STAFF REPORT
(PRELIMINARY PLAT)

CASE NUMBER: SUB 2002-41 -- LIBERTY PARK ADDITION

STAFF REPORT
(FINAL PLAT, PRELIMINARY PLAT APPROVED 5/30/02)

CASE NUMBER: SUB 2002-41 -- LIBERTY PARK ADDITION

VICINITY MAP

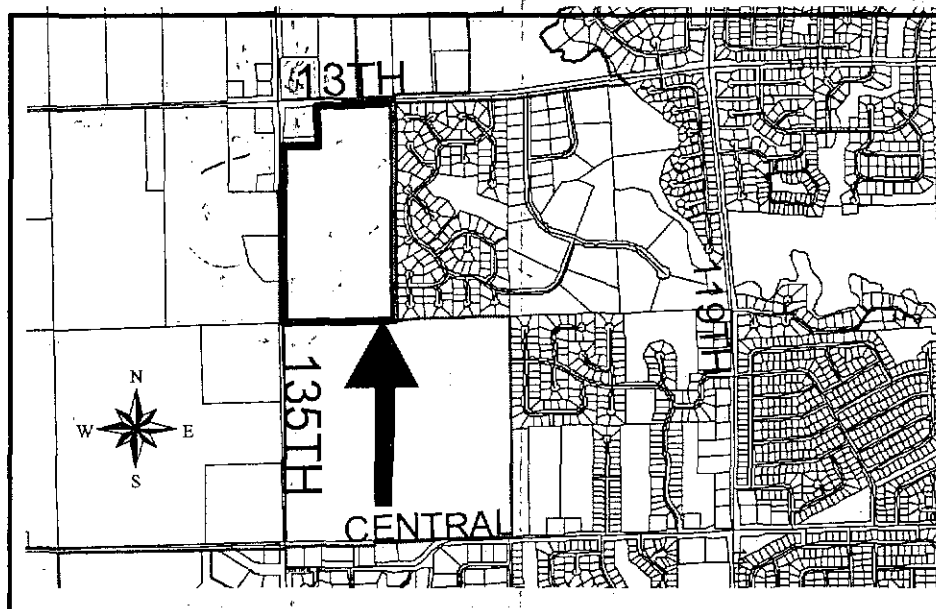
*Sewer Pump Station?
Capacity of Copper
Gate. Can we size them?*
